Land West of Fortescue Fields, Norton St Philip, Frome, Somerset

Heritage Report on Planning Application 2023/0640/FUL

Angel Architecture Ltd has been commissioned to assess the impact of proposed development on the setting of heritage assets in respect of application reference 2023-0640-FUL. It does not seek to address the other issues relating to planning, landscape character or trees. This report has been prepared by Kim Sankey BA(Hons), DipArch, AADipCons, RIBA on behalf of Norton St Philip Parish Council.

Fig.10 Looking north towards The George Inn. Footpath FR11/1 emerges in High Street. Extract from Explore Somerset – Rights of Way, key views of the application site are from within Church Mead.

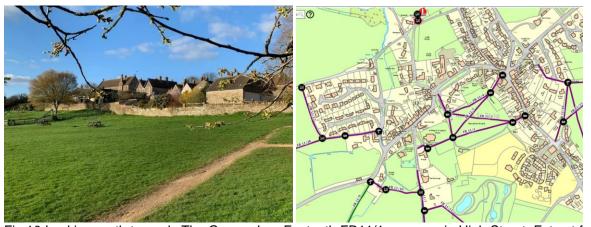
- 7.8 The Church 'precinct' and application site can be seen in the same viewshed from a range of locations from the public footpaths on the FR11/1, FR11/2, FR11/3, FR11/4, FR11/5 and FR11/10. The application site is seen more readily in views from the Church tower are of unspoilt open pasture (Figure 1 & 10 refers). From these viewpoints it is possible to experience the form of the listed Church building, the other

Fig.21 Extract from planvu.co.uk/mdc/ interactive mapping. The protected local green spaces include Church Mead and the school playing field, the churchyard is an open space of local significance.

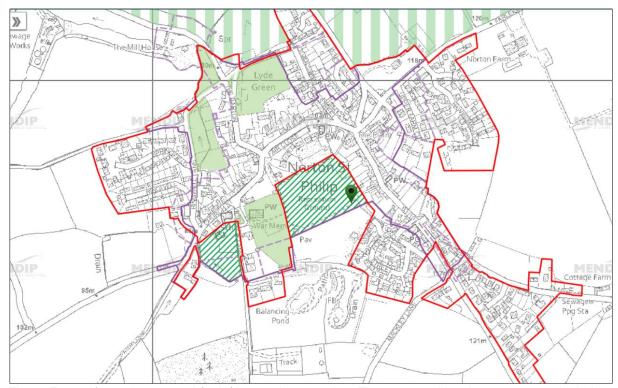
- 7.4 The open aspect seen at Figure 21, (that is integral to the two clusters of buildings around the Church and The George Inn linked by Bell Hill) would be eroded by the placement of buildings closing the gap, and the link to open countryside would be lost together with the legibility of the historic settlement pattern. This would result in a failure to comply with the Local Plan Policies DP1 Local Identity and Distinctiveness, DP3 Heritage and Conservation and DP7 Design and Amenity of New Development.
